## 1 ADDENDUM #2

**All clauses set forth in the Bidding Documents, Contract Documents and General Requirements of the original Contract Documents shall apply to and govern this work. The addendum refers to changes and additions to the original Contract Documents and is to be read in conjunction with the same. All other parts of the original Contract Documents are to be considered as applying to the work of this Contract with the exceptions and changes as noted below.**

DRAWING NUMBER: SK-01

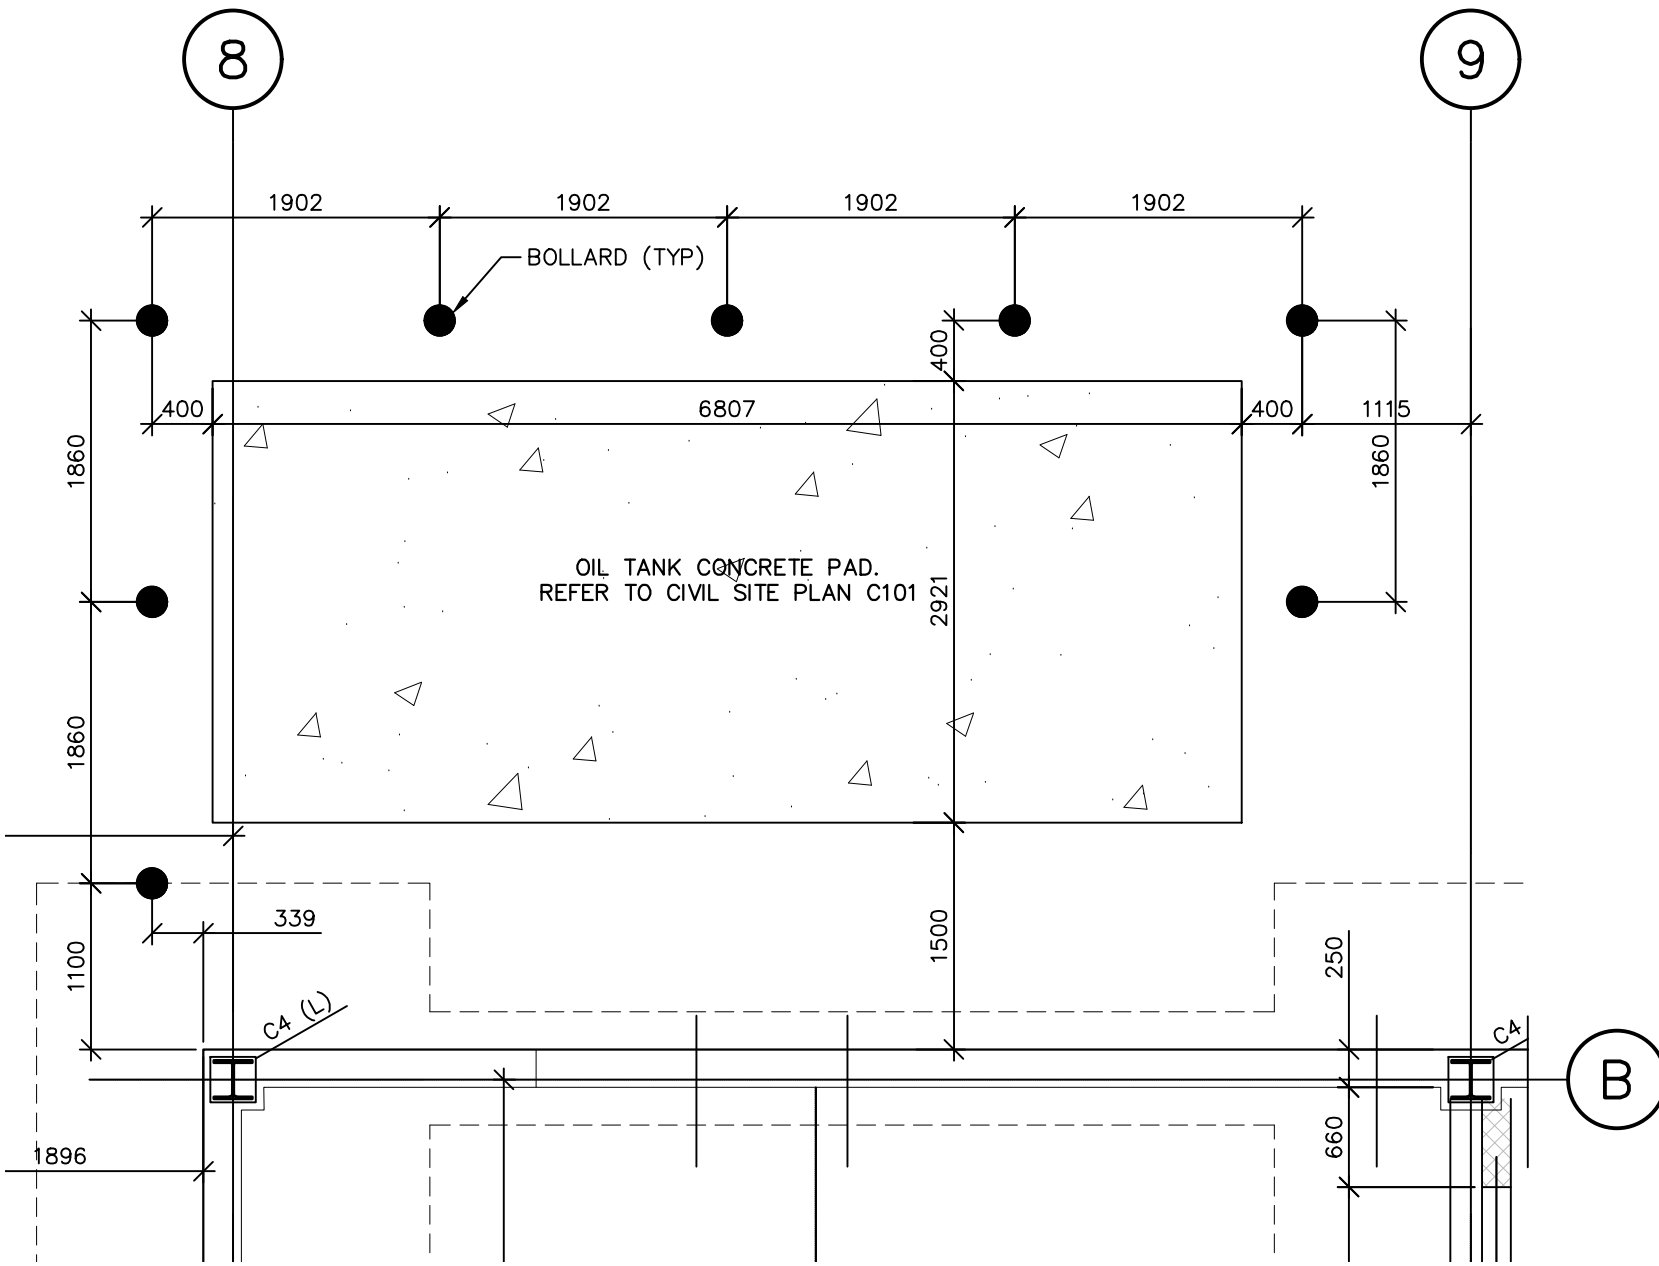
- .3 Reference Drawing S102 - Foundation & Ground Floor Plan South & Mezzanine Framing Plan:
  - .1 Refer to SK-01, attached and forming part of this addendum, for eight (8) additional exterior bollards around the Oil Tank on East side of new building.
